Planning & Zoning Board Meeting

- 2.** Consideration and Recommendation: **Venezia Townhomes Final Subdivision Plan Review**

TO: Howey-in-the-Hills Planning Board
CC: J. Brock, Town Clerk, S. O'Keefe, Town Administrator
FROM: Thomas Harowski, AICP, Planning Consultant
SUBJECT: Venezia Townhomes Final Subdivision Plat
DATE: January 20, 2022

TO: Howey-in-the-Hills Development Review Committee
CC: J. Brock, Town Clerk; S. O'Keefe, Town Administrator
FROM: Thomas Harowski, AICP, Planning Consultant
SUBJECT: Venezia Townhomes Final Subdivision Plan
DATE: January 4, 2022

C101

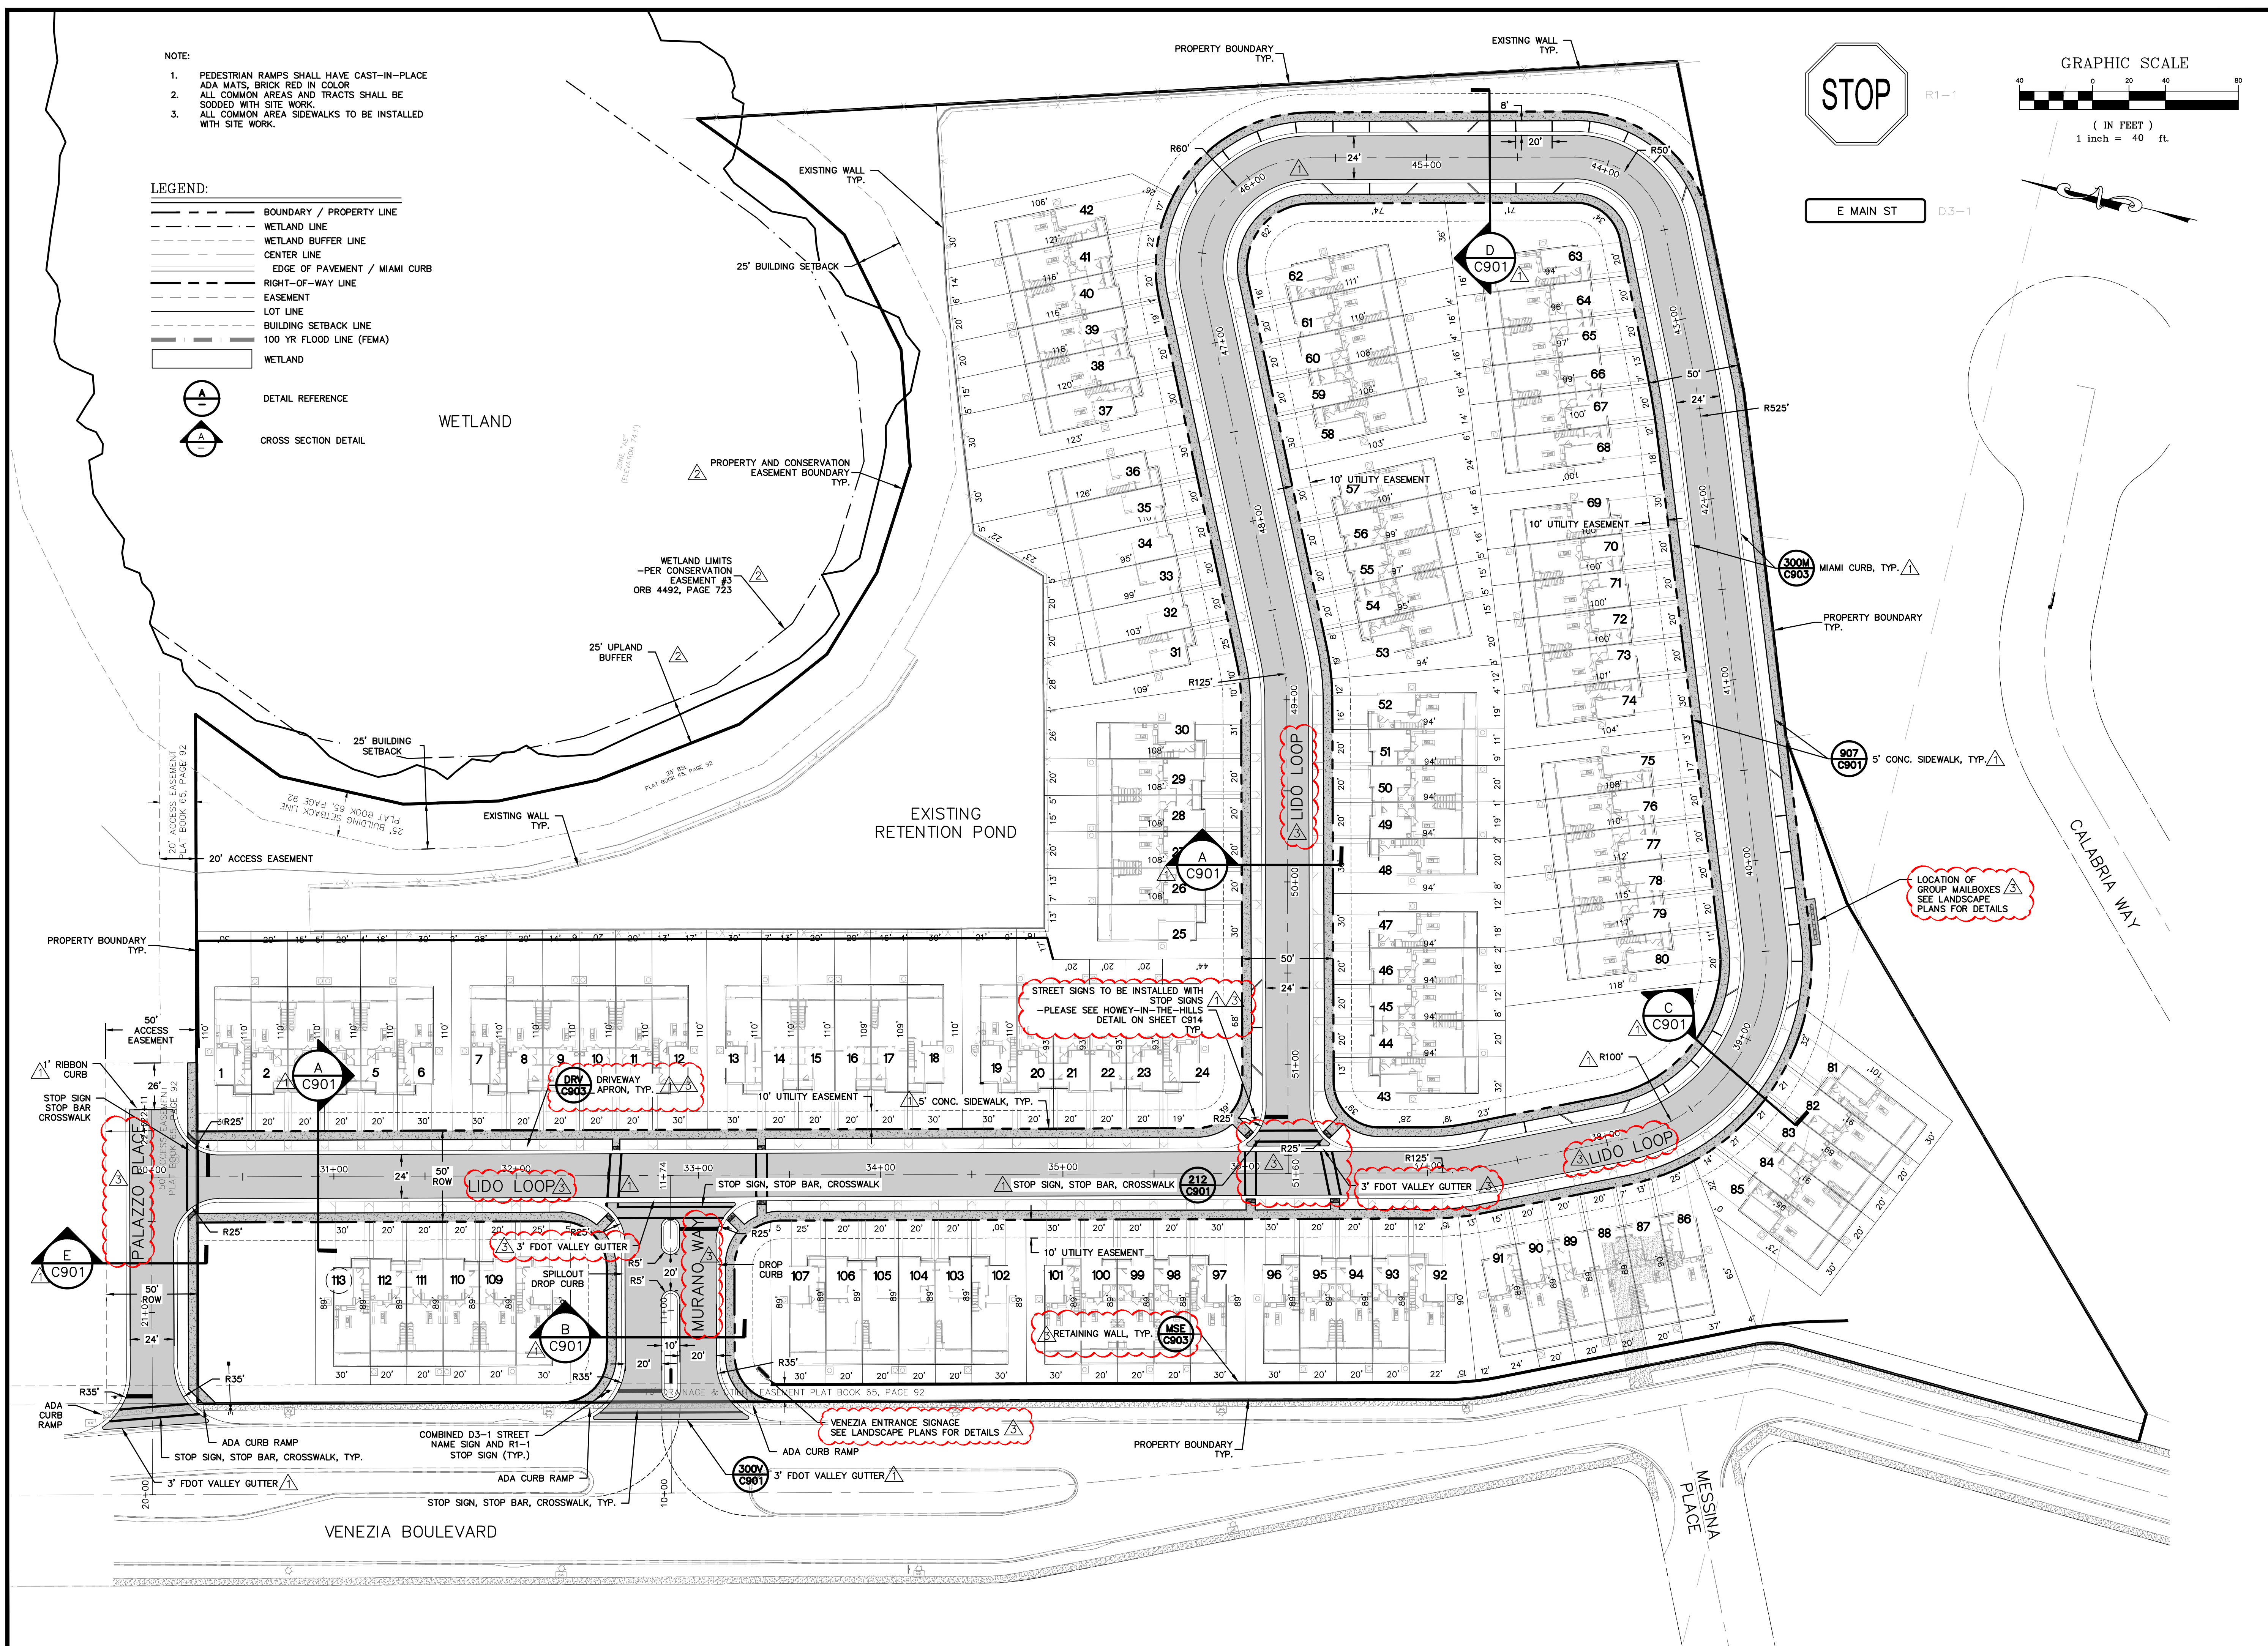
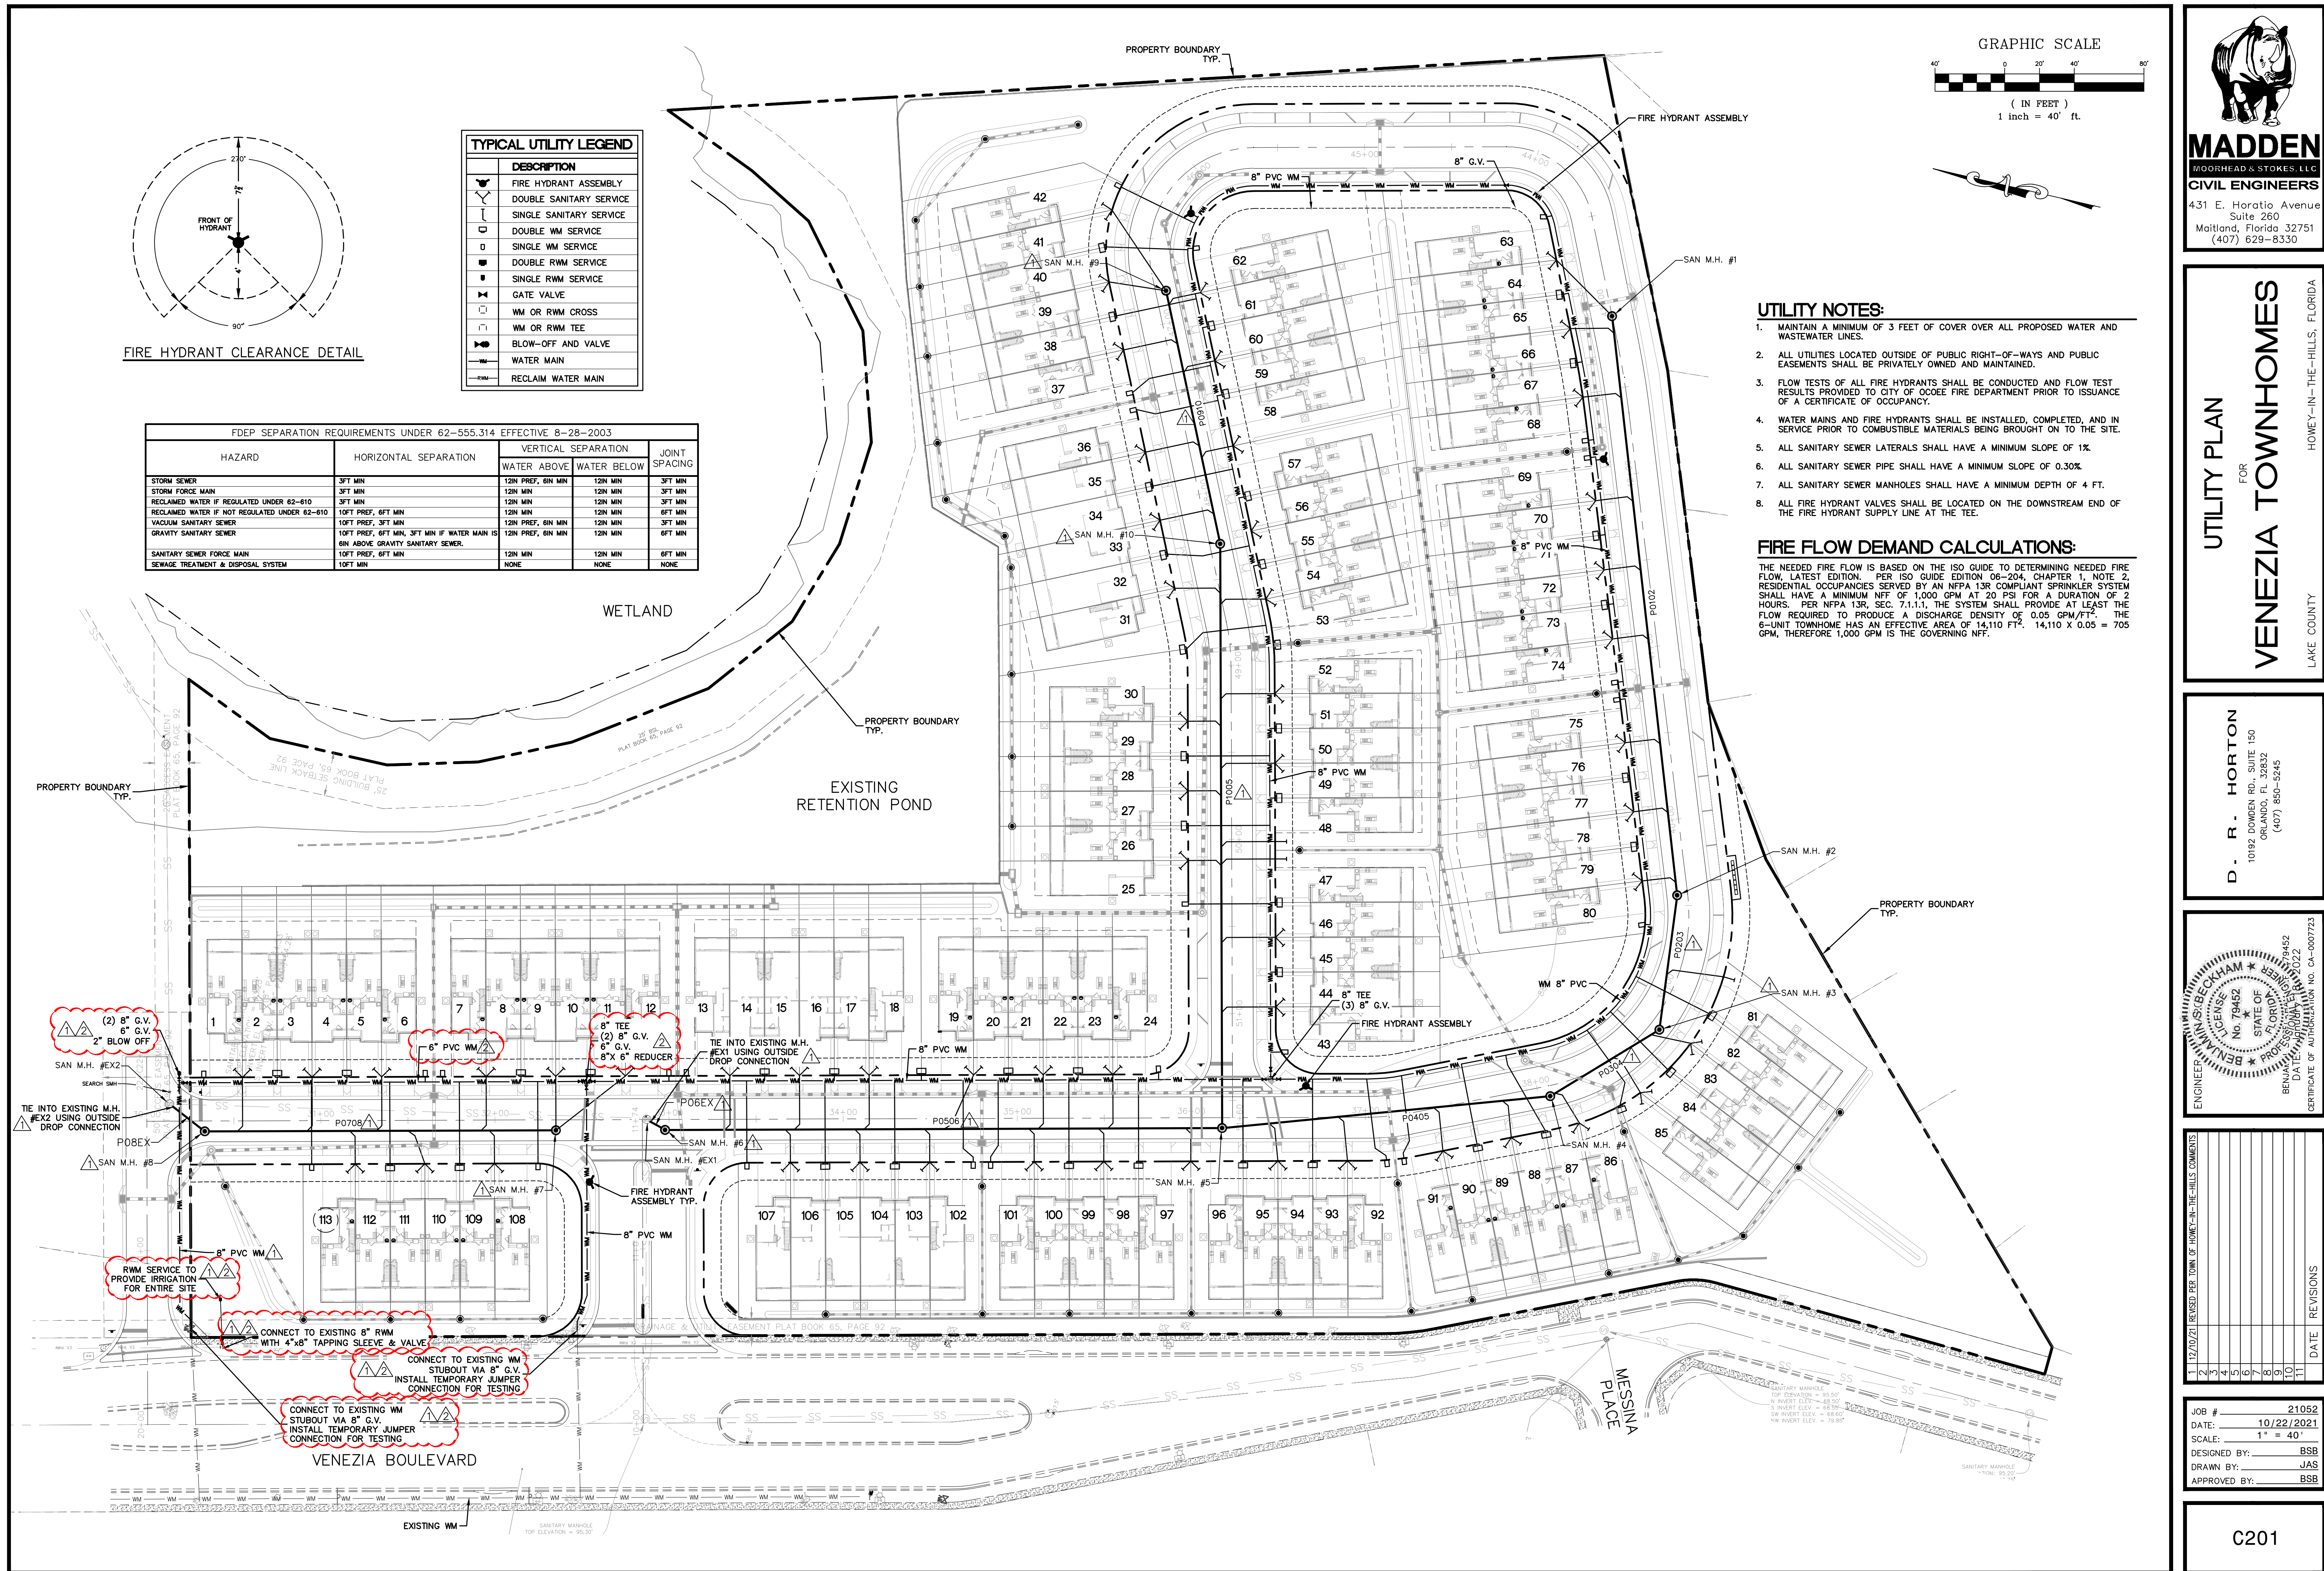
Comment 2: Pedestrian crossing and sidewalk ramps need to be provided as an extension of the sidewalks on the entrance road across the intersection, so the pedestrian linkage is in a u-shape. One intersection was modified, but the second intersection was not.

Comment 1: The notes stated that a group mail station was provided, but it was not clear on the plans where it is located. Some parking and pedestrian access needs to be provided where the station is located. Will the post office permit more than one location within the project?

Comment 2: A subdivision entrance sign should be provided at the main entrance from Venezia Boulevard including location and appropriate landscaping. A secondary subdivision identification sign should be provided at the north entrance. It does not seem that an identification on SR 19 is sufficient.

Comment 1: Add crosswalks to all legs of the intersection at lots 96-97 & 94-95.

Comment 6: Call out 3' valley gutters on the internal intersections.

Response: Please see added crosswalks in front of lots 94 & 97 on Sheet C101, completing the u-shape linkage.

Response: Please see group mailbox location on Sheet C101.

Response: Please see subdivision entrance sign on Sheet C101.

Response: Please see added crosswalks on Sheet C101.

Response: Please see added 3' Valley Gutter callouts on Sheet C101.
